CITY PLAN COMMISSION STAFF REPORT

Metro North Crossing UR Plan

CD-CPC-2020-00176 – Rezoning with plan

Report Date: April 01, 2021
Case Number: CD-CPC-2020-00176
Project: Metro North Crossing

PRELIMINARY SITE PLAN 01

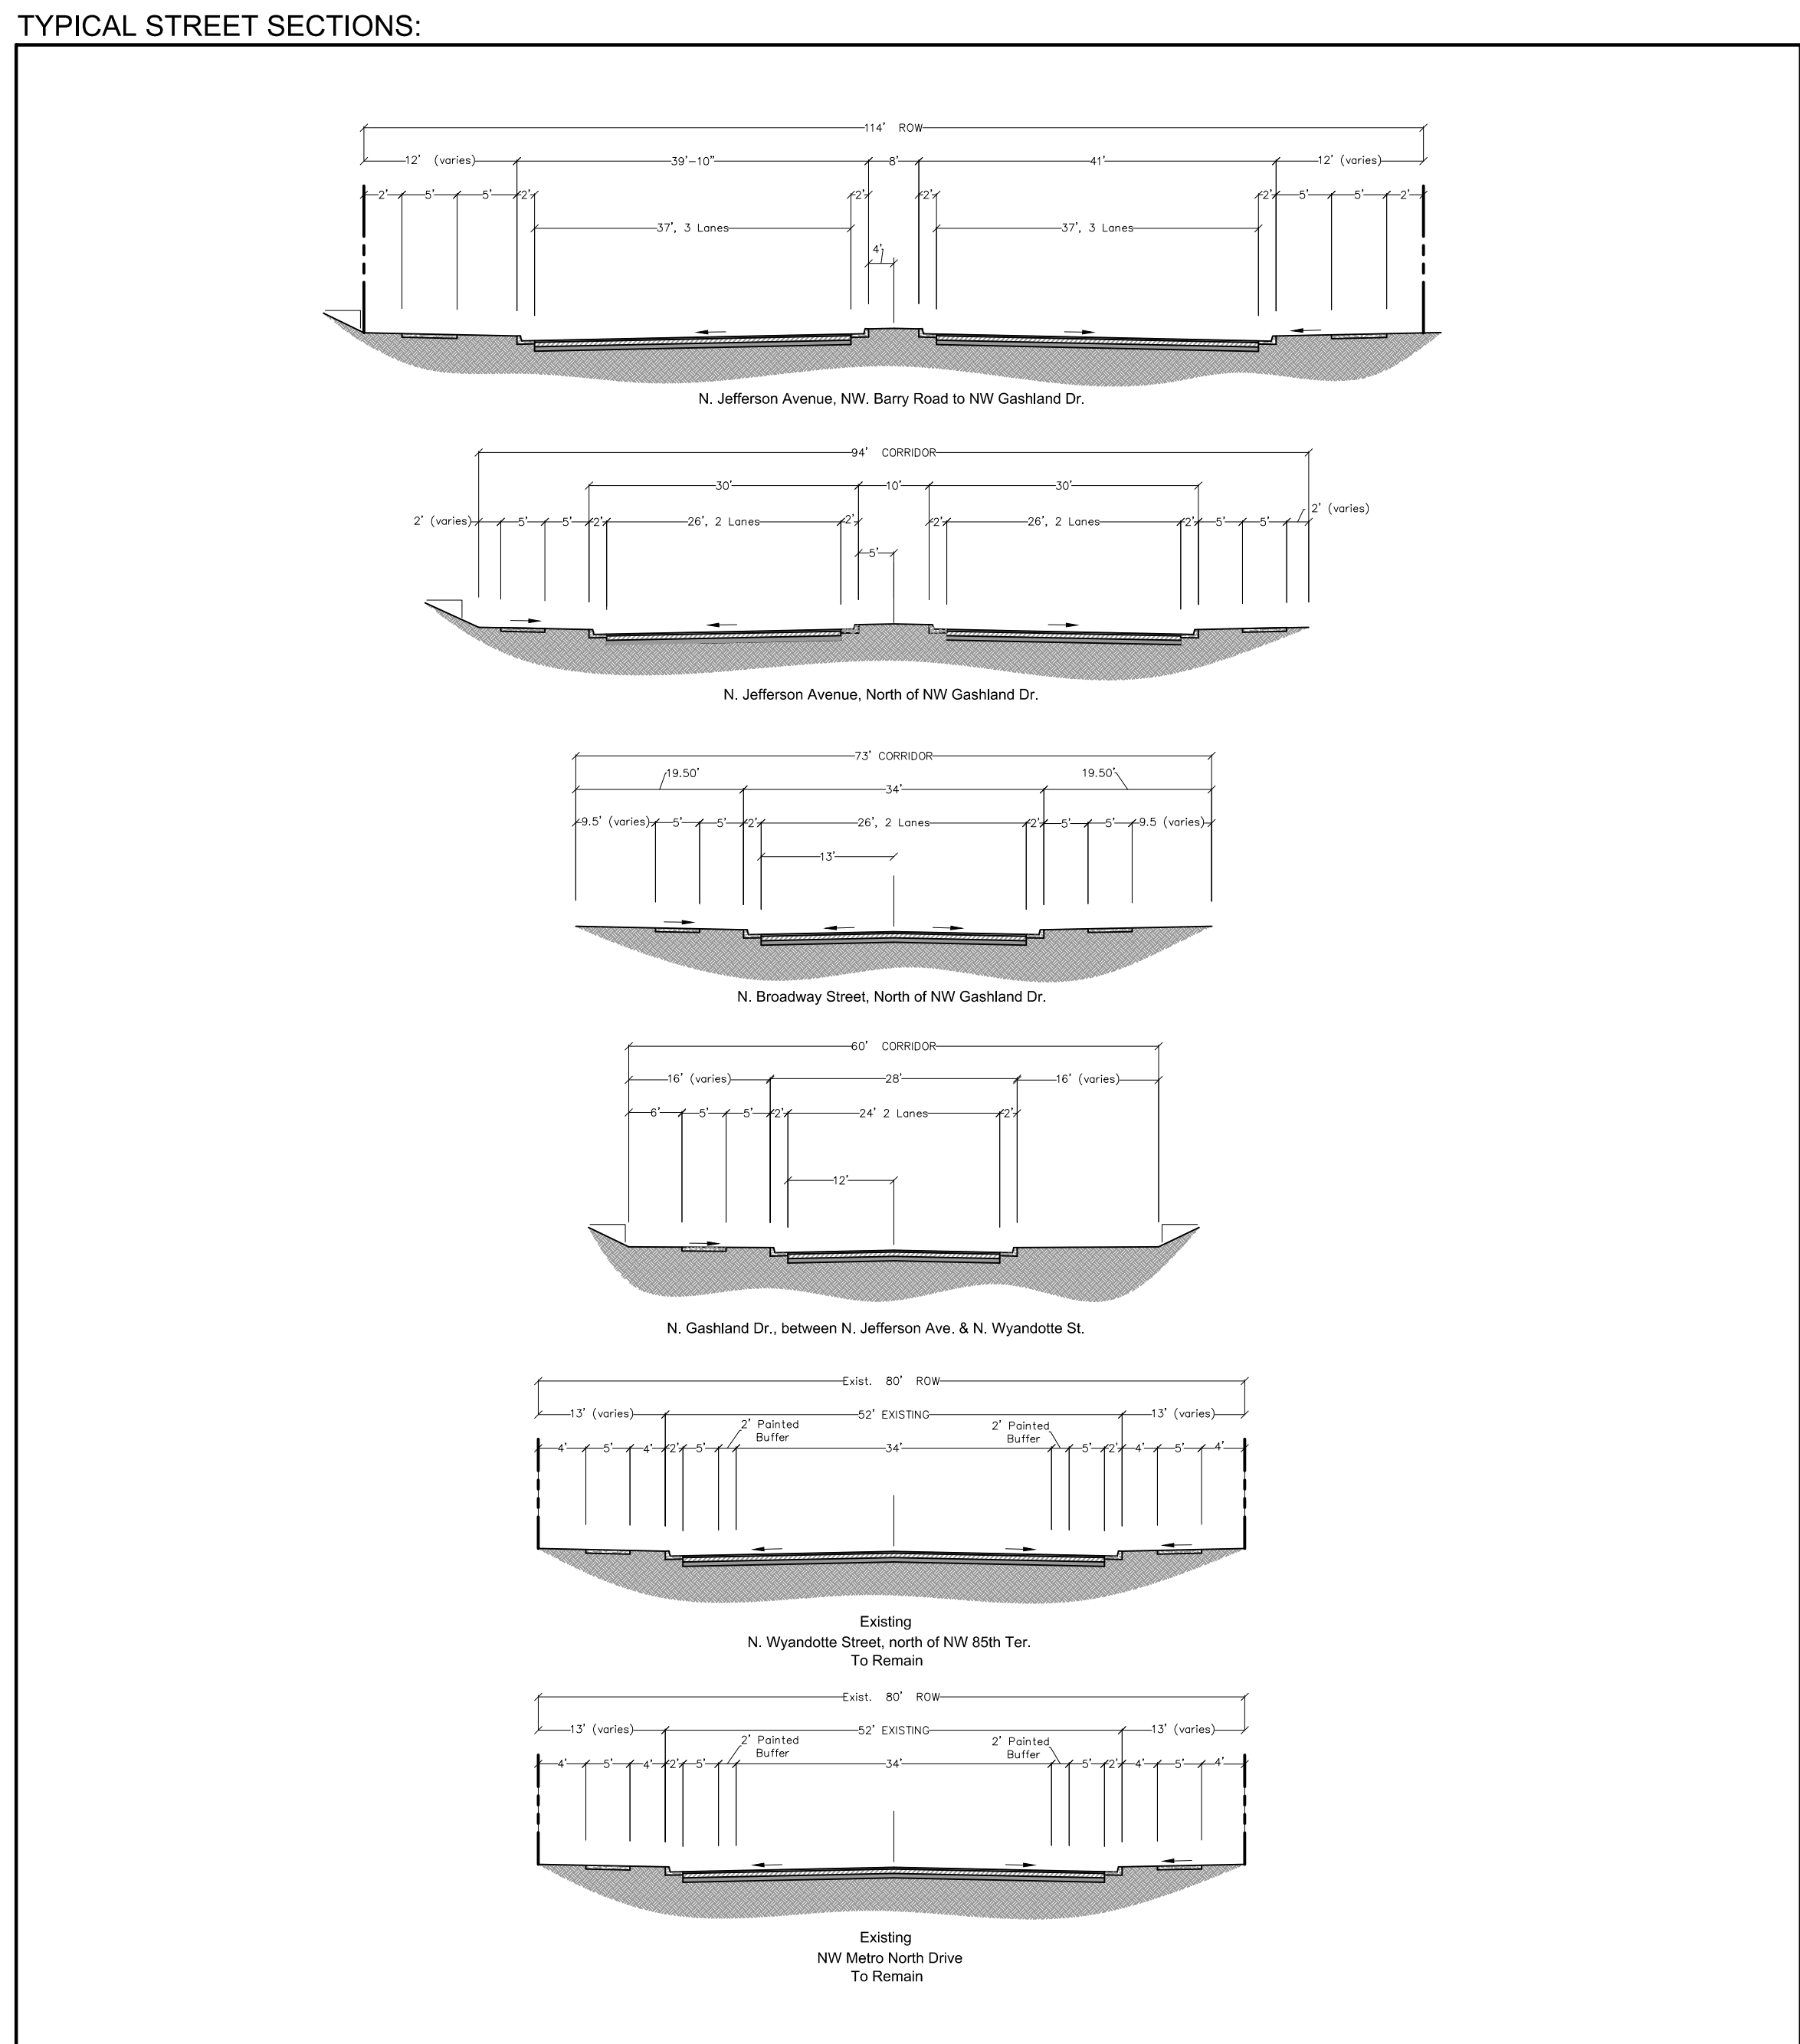
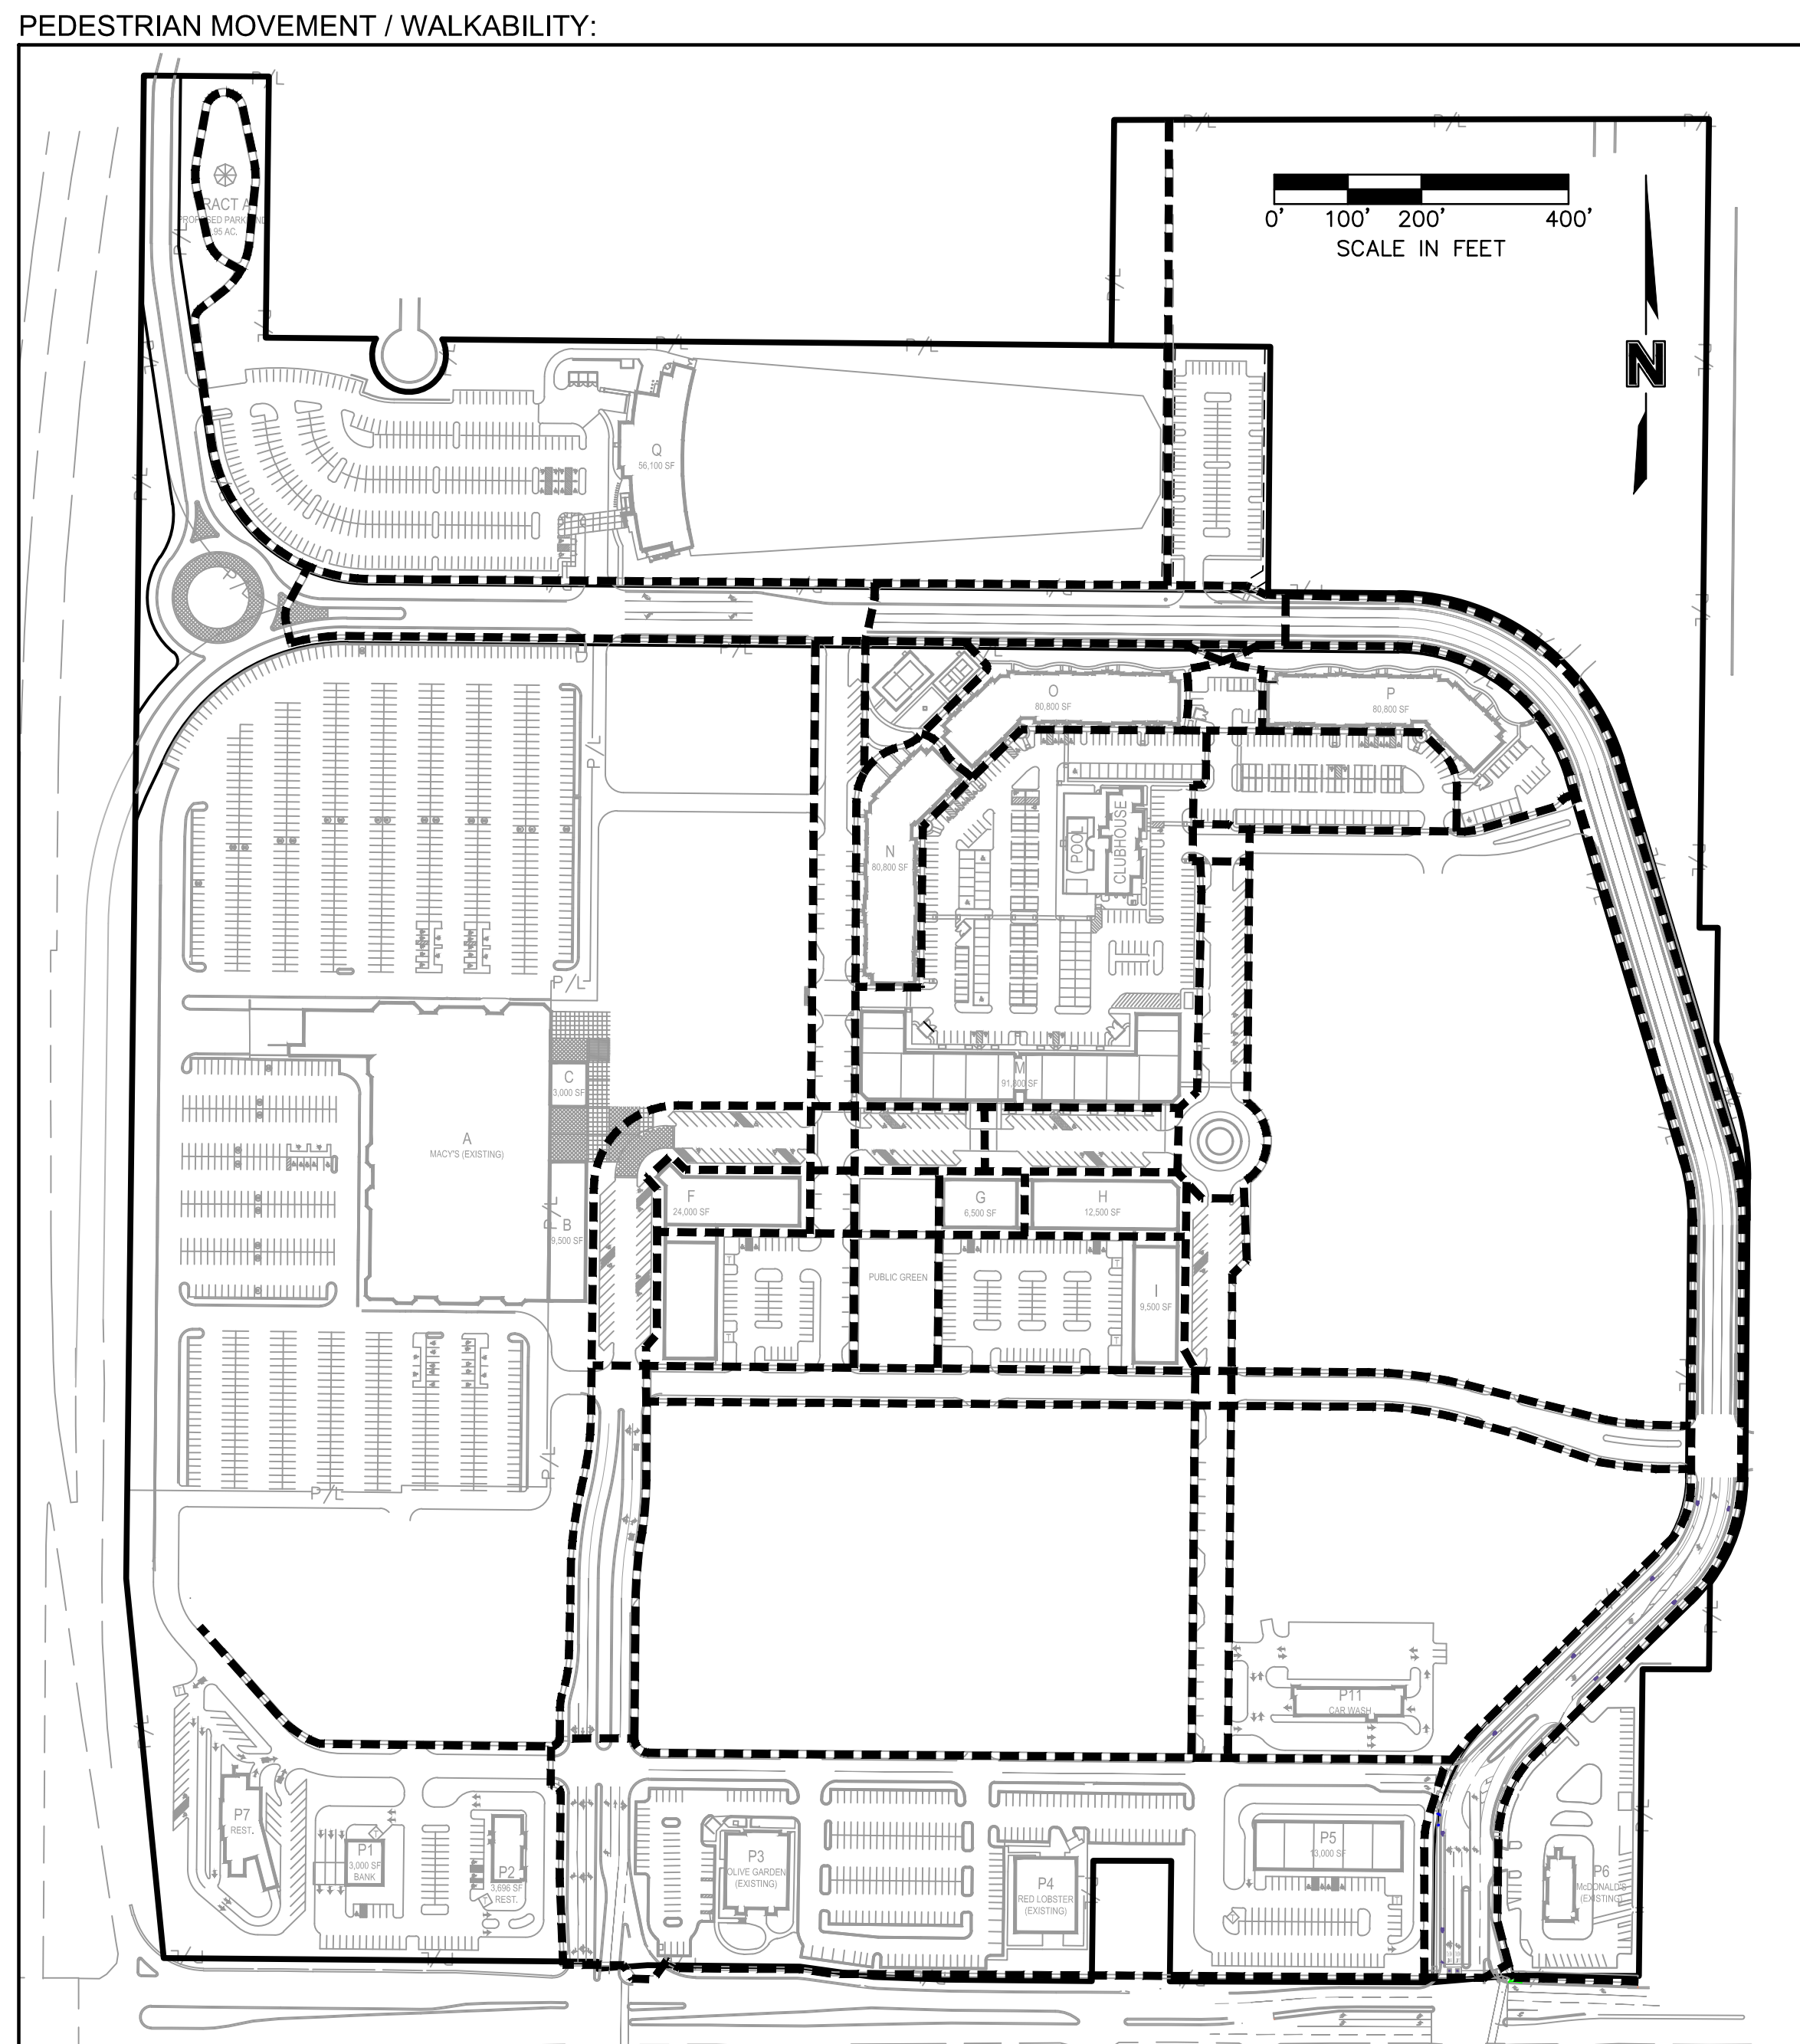
1. Revise phasing plan to reflect phase 2 as projects identified on this plan and phase 3 as future projects not shown on plan. Revise Plans and Resubmit (4/01/2021)

2. Put the public green in a tract and provide proposed programming of the dedicated public space. Revise Plans and Resubmit (4/01/2021)
3. Revise design standards to provide for minimum transparency requirements. Revise Plans and Resubmit (4/01/2021)

4. Proposed preliminary plat changes and possible replat. Show lots that are planned to be replatted via minor subdivision. Revise Plans and Resubmit (4/01/2021)

5. Renumber all lots per current approved plats and update proposed replat lot numbers to match. Revise Plans and Resubmit (4/01/2021)
6. Add language calling for additional landscape treatment and requirement along public streets. This language shall call out all outlots along NW Barry Road and N. Wyandotte Street. Revise Plans and Resubmit (4/01/2021)
